# Rainforest Alliance

## Methodology Assessment Report Report for:

The Field Museum and TerraCarbon

# The Field Msueum VCS MTA (revision) 12

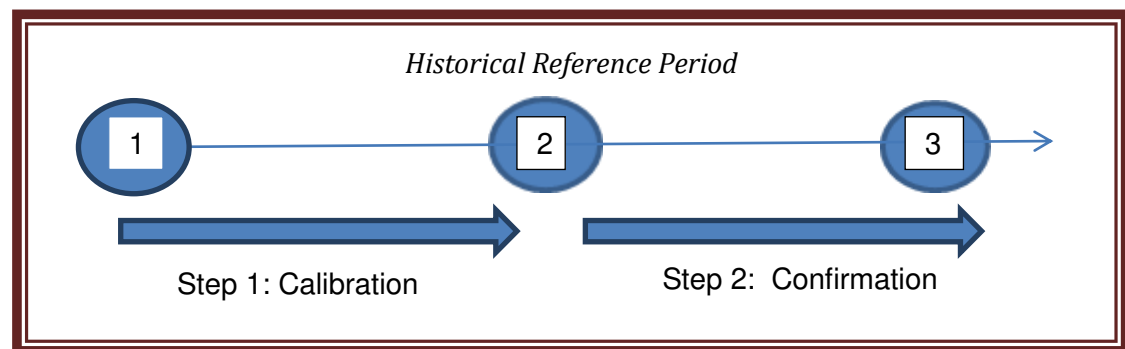
Land cover change modeling requires two phases; calibration and confirmation. The historical reference period is divided into 2 time steps. Three classified images of remotely sensed data are needed, (1) an origin date, or the beginning of the time series, (2) an intermediate date, ideally close to the mid-point in the time series and (3) a final date, which is within two years of the project start date. These three dates define the two time steps used for modeling as shown below.
